Re: Comment on 45-day language (Docket No. 07-BSTD-1)

Section 143(a)1A4, provides an exception to the requirement to install a cool roof on nonresidential buildings with low-sloped roofs, in climate zones 2-15 if a roof with thermal mass is installed. This exception currently states:

Figure 9. Membrane temperatures and roof heat fluxes nineteen months into experimental program.

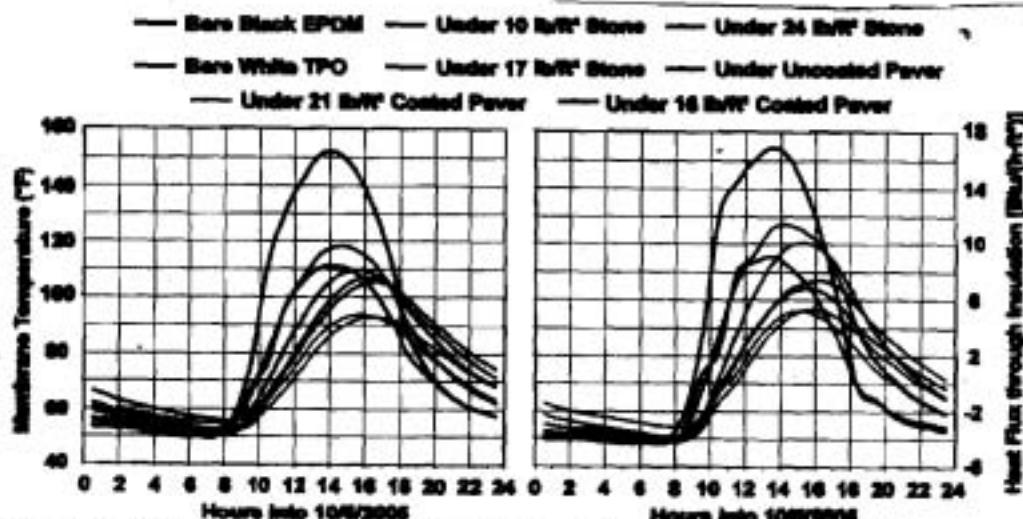
- After 18-months 17 lb/ft² ballasted roofs are as effective as cool roofs in mitigating peak demand (See the attached Figure 9).

In Figure 9 the blue line represents the results from the white TPO, while the green line represents the 17 lb/ft²-ballasted system. The graph on the left shows a plot of membrane temperature vs. time for October 5, 2005, nineteen months after the test was initiated. The 17lb/ft² ballast loading has a slightly lower peak temperature than the white membrane.

The graph on the right shows a plot of heat flux vs. time for this same date. The white membrane has a slightly lower peak heat flux than the 17 lb/ft² ballasted system, however the ballasted system delays the peak heat flux by an additional 2-hours.

"Roof constructions that have thermal mass over the roof membrane with a weight of at least 25 17 lb/ft²."
